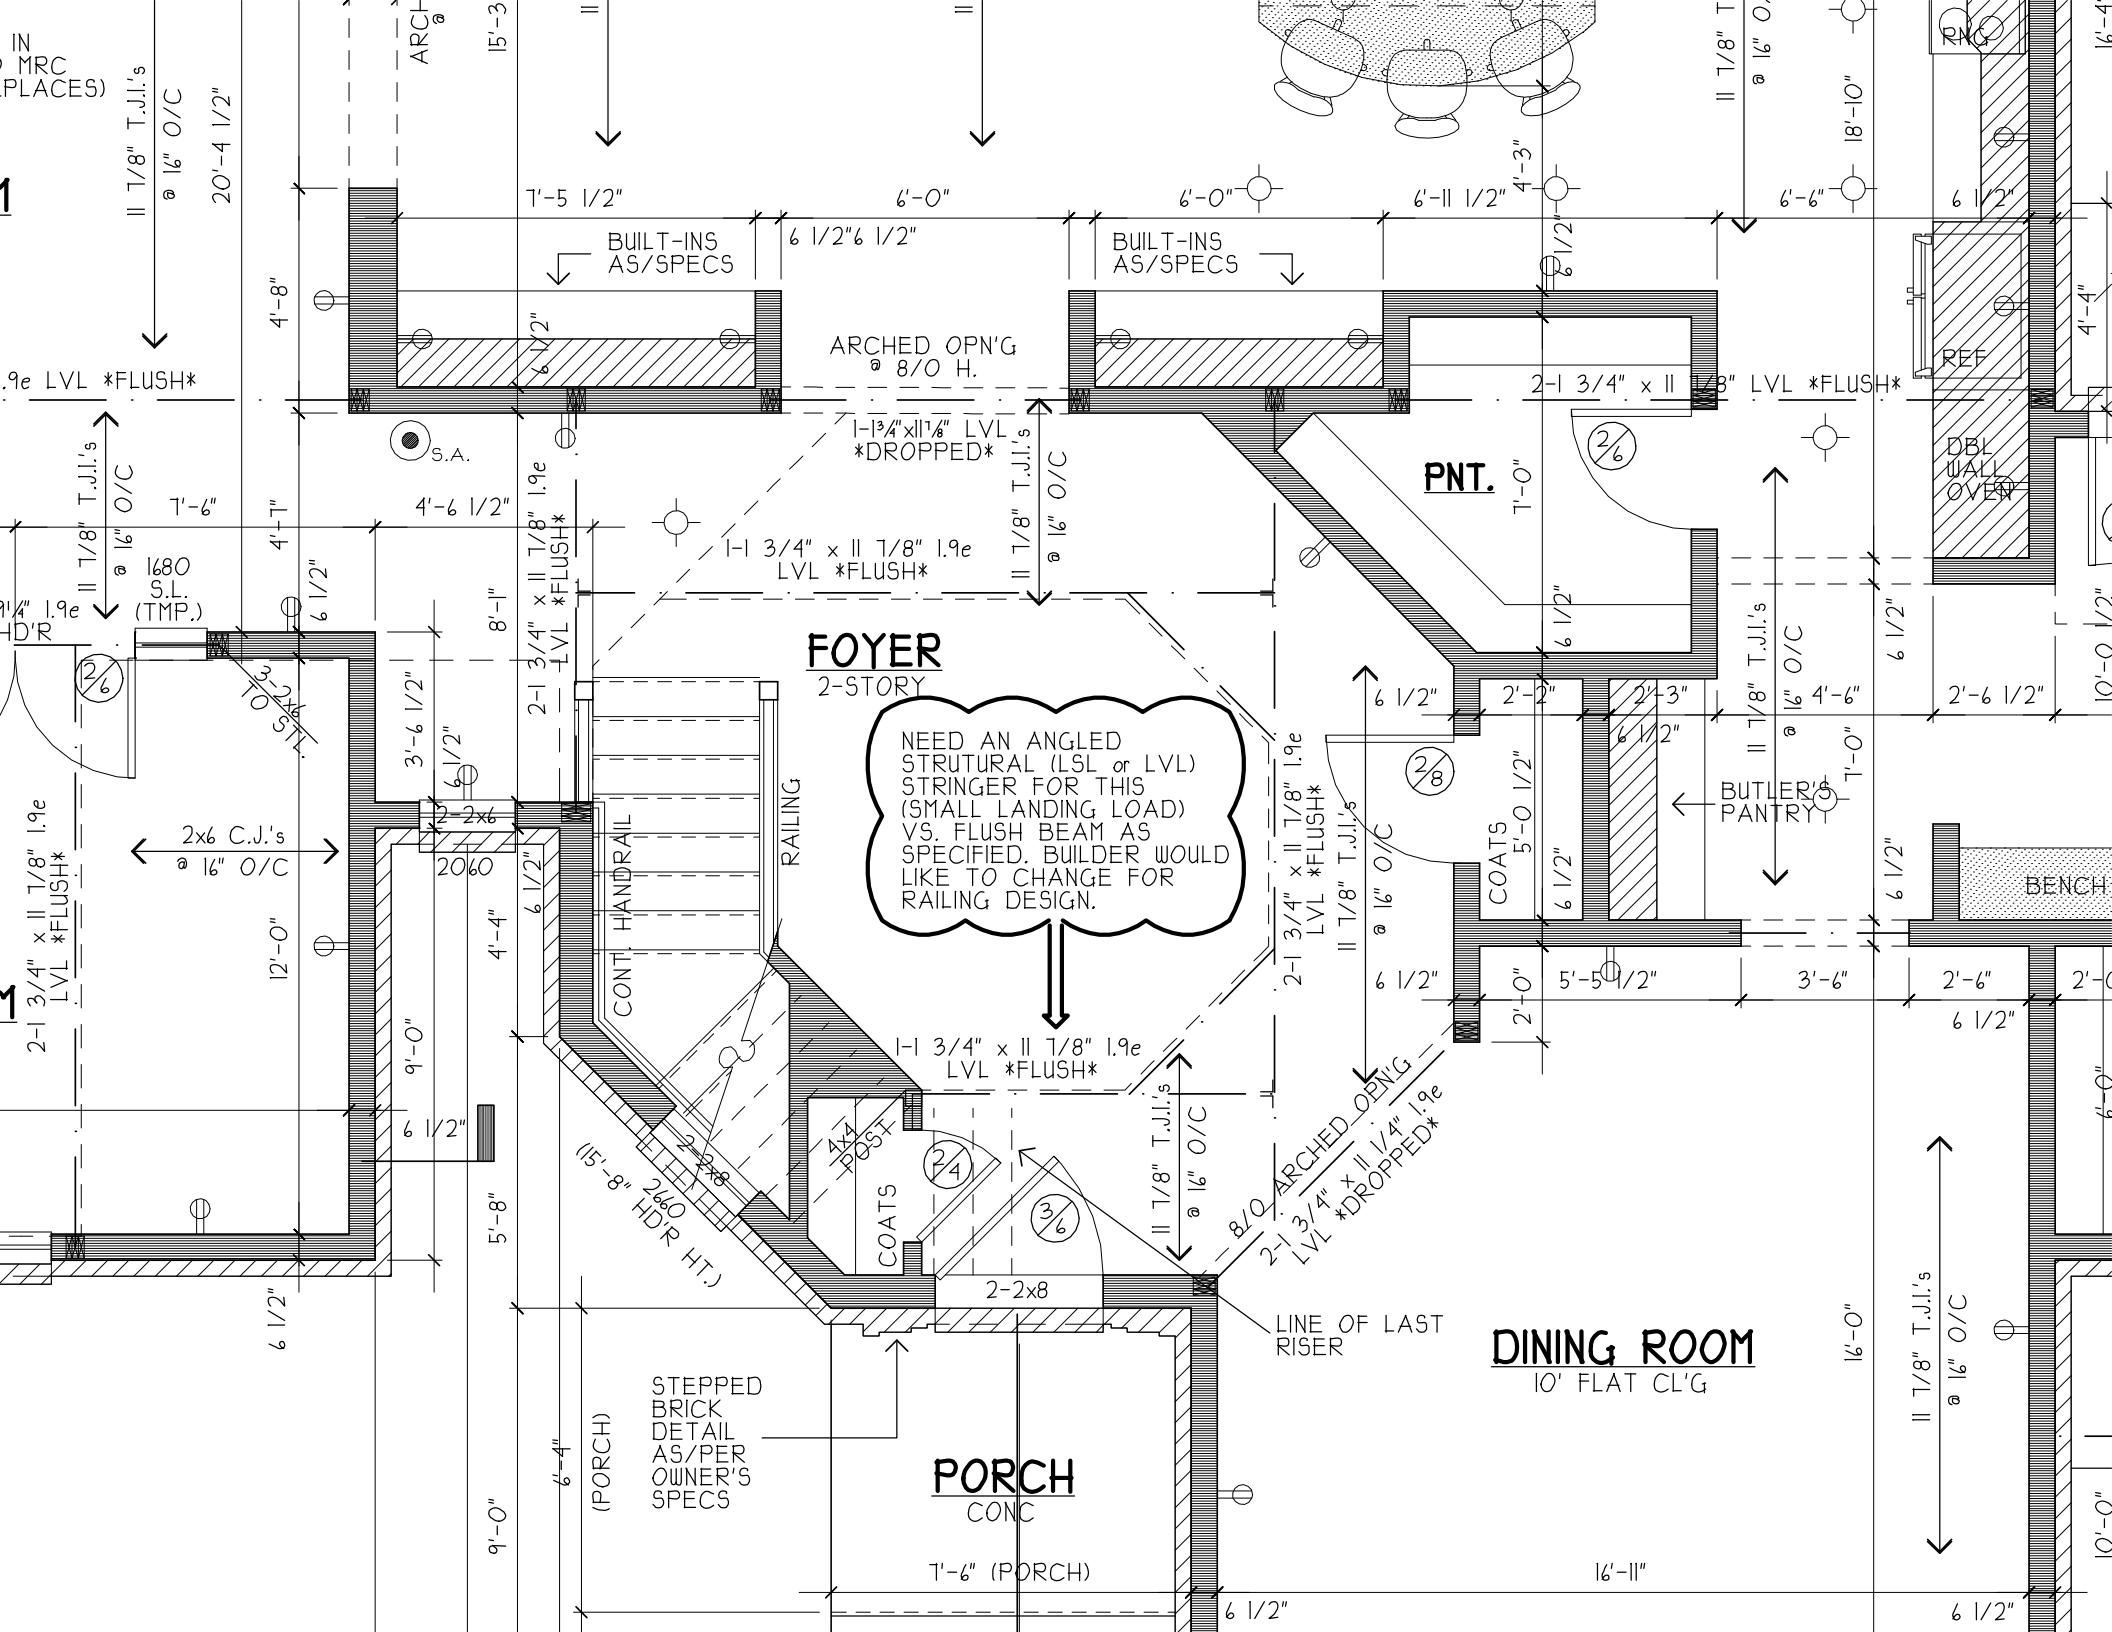
FOYER
2-STORY
PNT.
DINING ROOM
10' FLAT CL'G
PORCH
CONC
NEED AN ANGLED STRUTURAL (LSL or LVL) STRINGER FOR THIS (SMALL LANDING LOAD) VS. FLUSH BEAM AS SPECIFIED. BUILDER WOULD LIKE TO CHANGE FOR RAILING DESIGN.
BUILT-INS AS/SPECS
ARCHED OPN'G @ 8/0 H.
1-1 3/4" x 11 7/8" 1.9e LVL *FLUSH*
2-1 3/4" x 11 7/8" LVL *FLUSH*
1-1¾"x11⅞" LVL *DROPPED*
2-1 3/4" x 11 7/8" 1.9e LVL *FLUSH*
2x6 C.J.'s @ 16" O/C
2-2x6
2060
2-2x8
2660 (15'-8" HD'R HT.)
4x4 POST
COATS
RAILING
CONT. HANDRAIL
BUTLER'S PANTRY
BENCH
REF
DBL WALL OVEN
RNG
LINE OF LAST RISER
STEPPED BRICK DETAIL AS/PER OWNER'S SPECS
8/0 ARCHED OPN'G
2-1 3/4" x 11 1/4" 1.9e LVL *DROPPED*
1680 S.L. (TMP.)
3-2x6 TO STL.
S.A.
7'-5 1/2"
6'-0"
6'-11 1/2"
6'-6"
7'-6"
4'-6 1/2"
2'-2"
2'-3"
4'-6"
2'-6 1/2"
5'-5 1/2"
3'-6"
2'-6"
7'-6" (PORCH)
16'-11"
